# SERVICE No. 207A BULLETIN

Piper Aircraft Corporation

**SUBJECT:** Inspection of Weld at Rudder Pedal Assembly  
(Part Nos. 40842-04 and 40842-05)

**MODELS AFFECTED:** PA-18 and PA-18A Super Cub - Serial Nos. 18-1 thru 18-7768  
inclusive

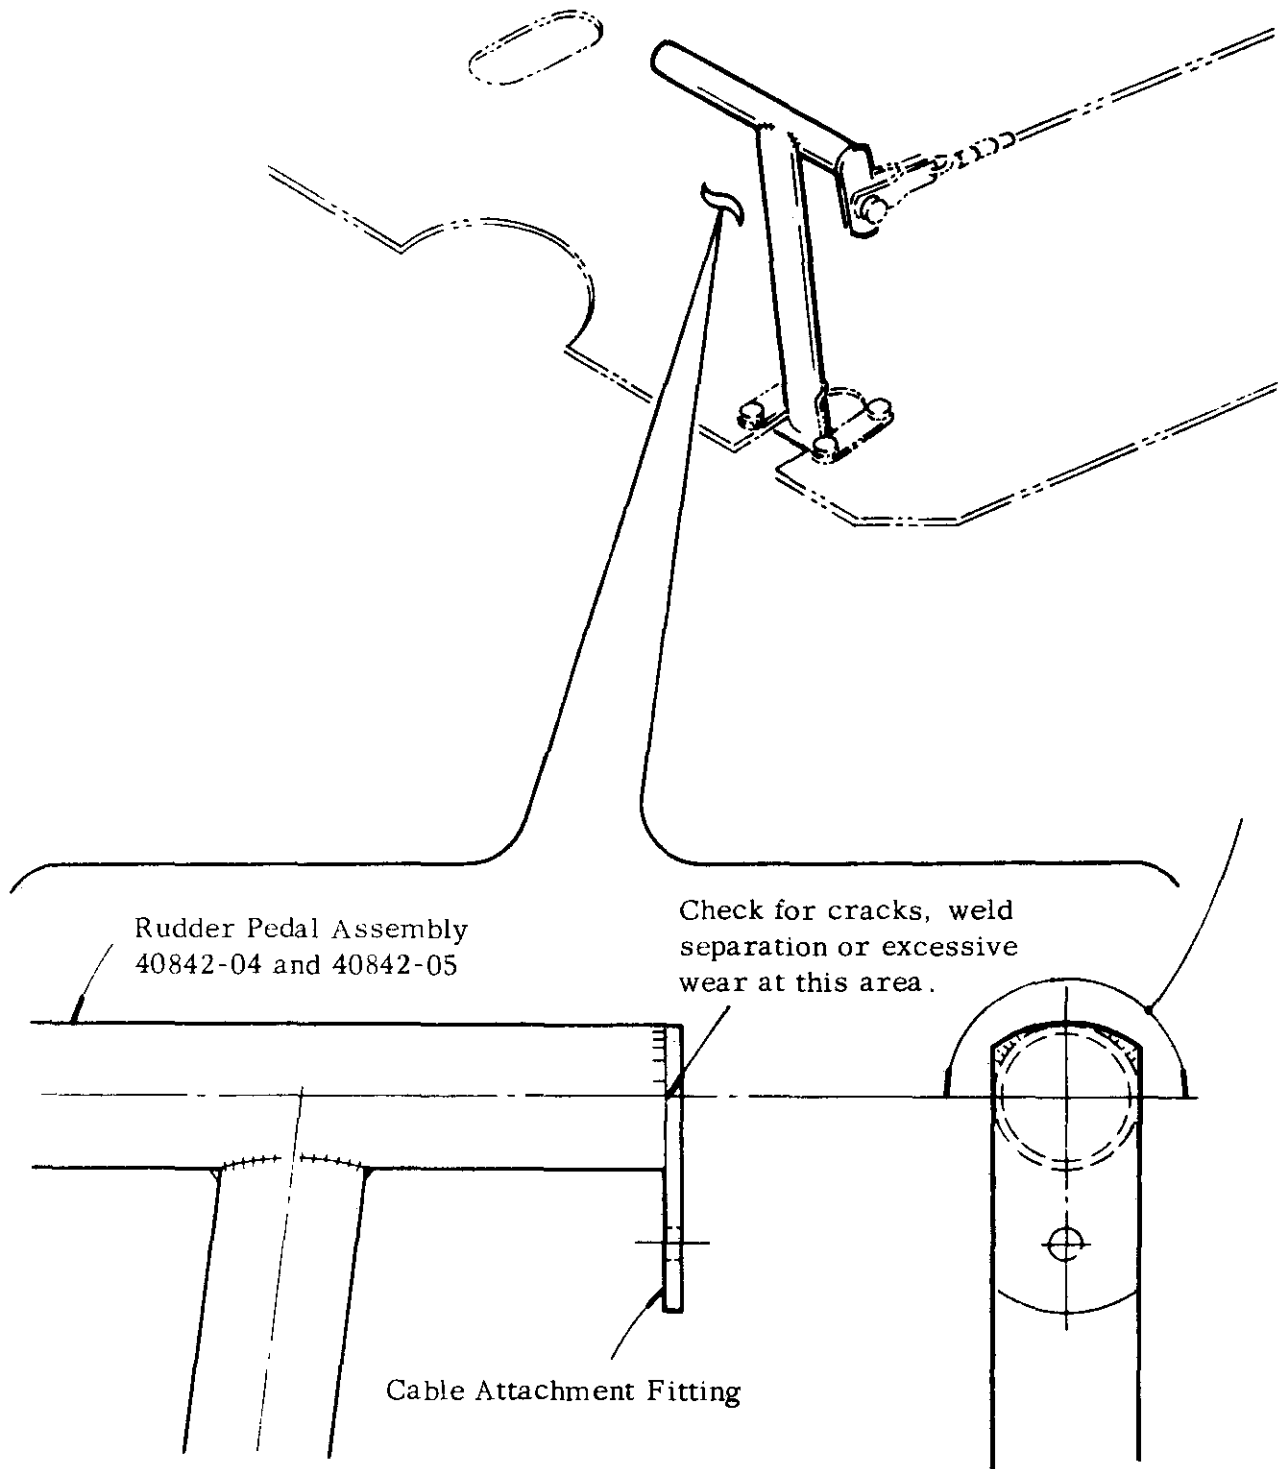
It is requested that a visual inspection be made of this weld for any evidence of separation, cracks in the weld, or excessive wear due to long time usage, in area referred to on the reverse side of this Service Bulletin.

If there is no evidence of weld separation, cracks or wear, the length of the weld should be inspected and if the length of the weld conforms to the dimensions shown in the sketch on the reverse side of this Service Bulletin, no further action is required.

If there is evidence of weld separation, cracks, excessive wear, or the length of the weld does not conform to the dimensions referred to on the sketch; the rudder pedal must be replaced prior to further flight.

Any cracks in weld, regardless of length of weld or location of crack, shall be cause for rejection of rudder pedal assembly.
